GENERAL REEVALUATION REPORT AND
SUPPLEMENTAL ENVIRONMENTAL
IMPACT STATEMENT II:

RIO GRANDE FLOODWAY,
SAN ACACIA TO BOSQUE DEL APACHE UNIT,
SOCORRO COUNTY, NEW MEXICO

BIOLOGICAL
ASSESSMENT

COMMENTS & RECOMMENDATIONS
On the
U.S. ARMY CORPS OF ENGINEERS BIOLOGICAL ASSESSMENT
For the
SAN ACACIA TO BOSQUE DEL APACHE UNIT
SOCCORO COUNTY, NEW MEXICO

Figure 5.1. RAS cross-section immediately downstream of San Acacia diversion dam without proposed action.

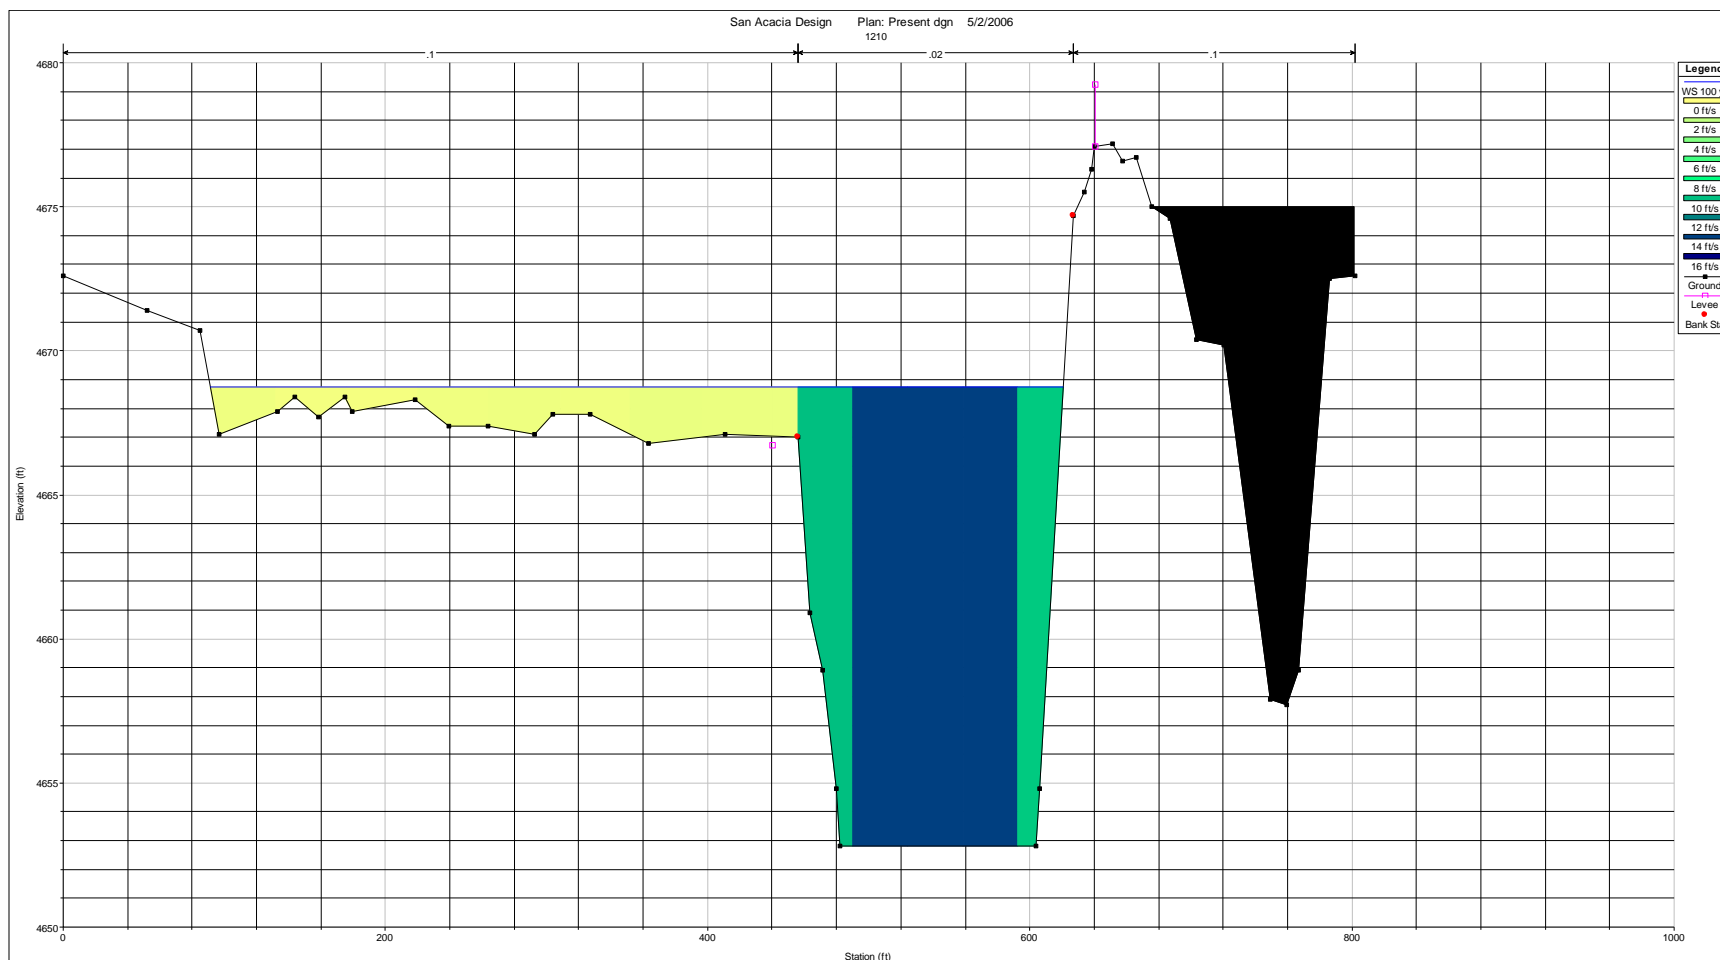
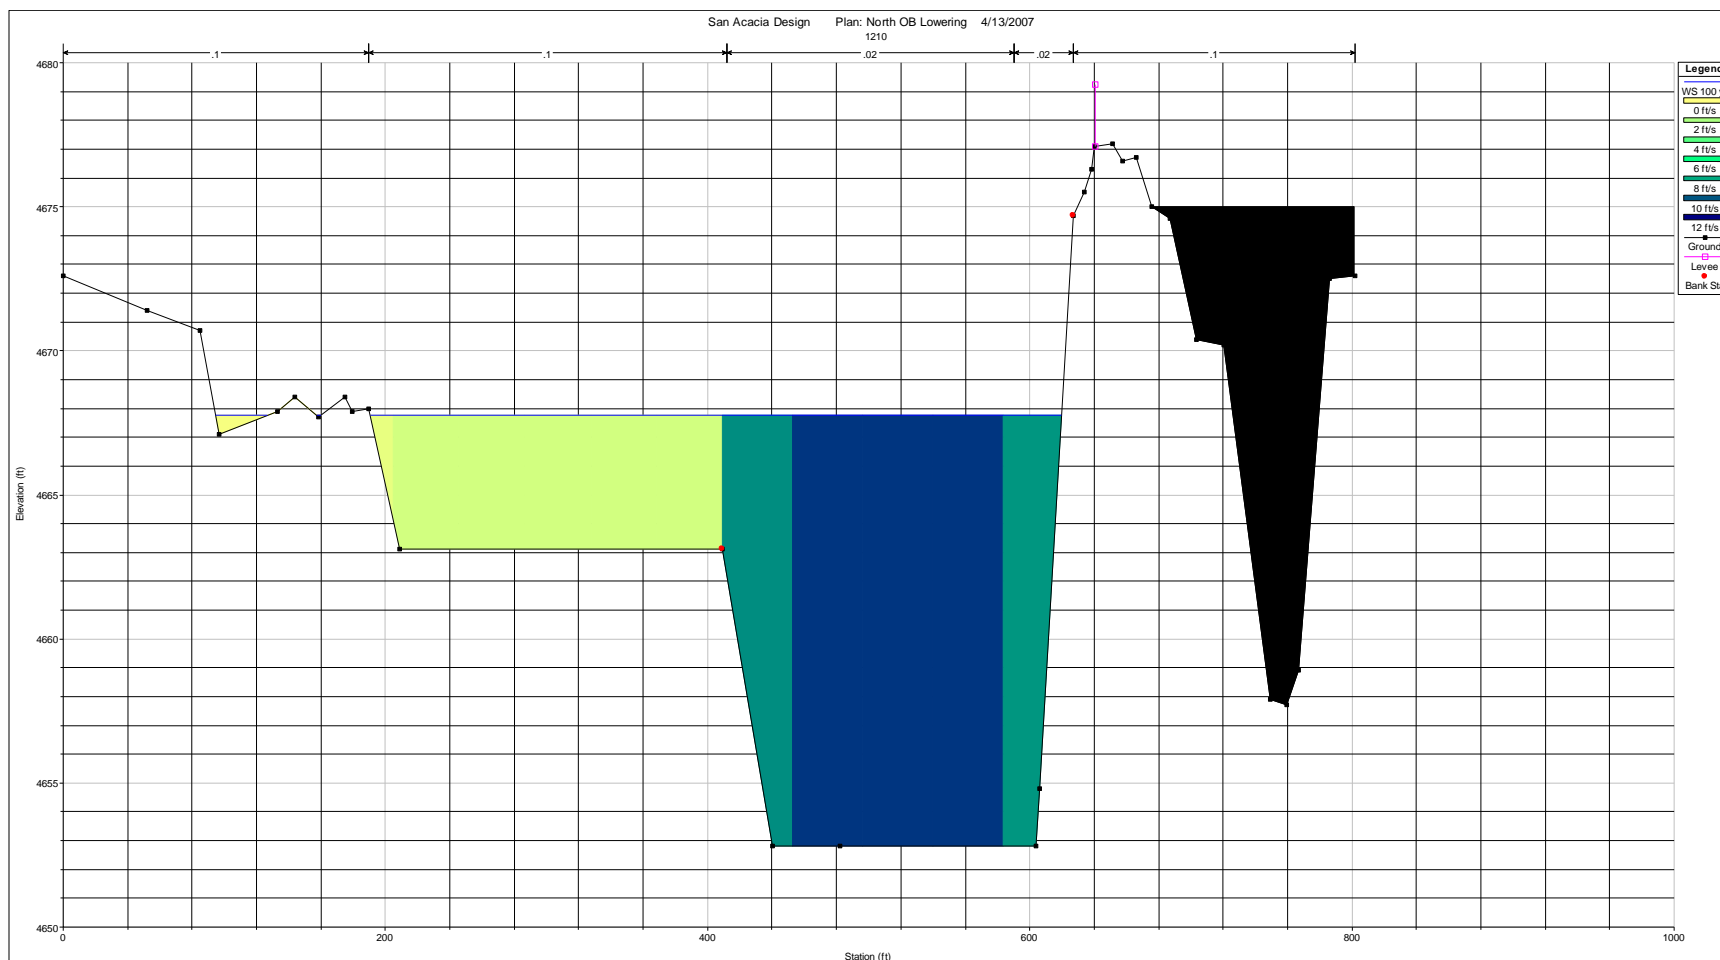
- 46) 5.1, Rio Grande Silvery Minnow, p. 77: The statement that the west bank for 0.75 mile downstream of the SADD is “generally unsuitable for silvery minnows and other fish species because of very high water velocities in this area” seems to refer to flood flows. This bank currently has riparian forest along its entire length and may provide habitat for this species under low-flow conditions. Habitat conditions here under varying flow conditions and their relationship to the vertical location of proposed channel modifications should be clarified. (also on page 79)

Response: This analysis focuses on in-channel baseflow along vertical bankline. The aquatic habitat where the soil cement wall would be installed has high water velocities as a function of river width, local slope, etc. The high water velocity is why a soil cement wall is appropriate for bank protection, and why this area is unsuitable as minnow habitat.

The comment is correct in stating that as flow increases, there will be increased area of low-velocity habitat in other areas of the channel. There is an area of low velocity habitat across the channel.
